# PRODUCT CHANGE NOTIFICATION

PCN-WD2015-07-1

**PCB connector**  
**Series 930-D-SMD(-DS)**  
 Tape-on-Reel version,  
 Part numbers see below

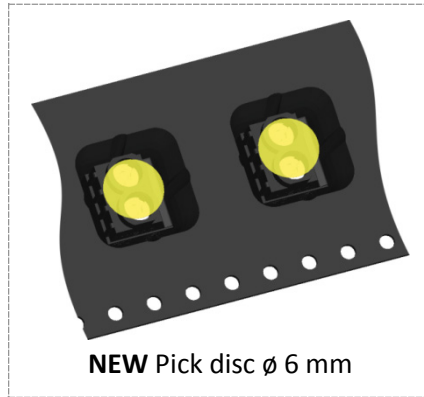
**TO DATE:** Parts bonded with pick disc  $\varnothing$  8 mm.

**NEW:** Parts bonded with pick disc  $\varnothing$  6 mm.

Depending on their position on the part, it is possible that pick discs of  $\varnothing$  8 mm for parts listed below glue to the sides of the carrier tape pocket which can cause blockages when picking the part prior to the placement process. Using the smaller pick disk with  $\varnothing$  6 mm avoids this adverse effect.
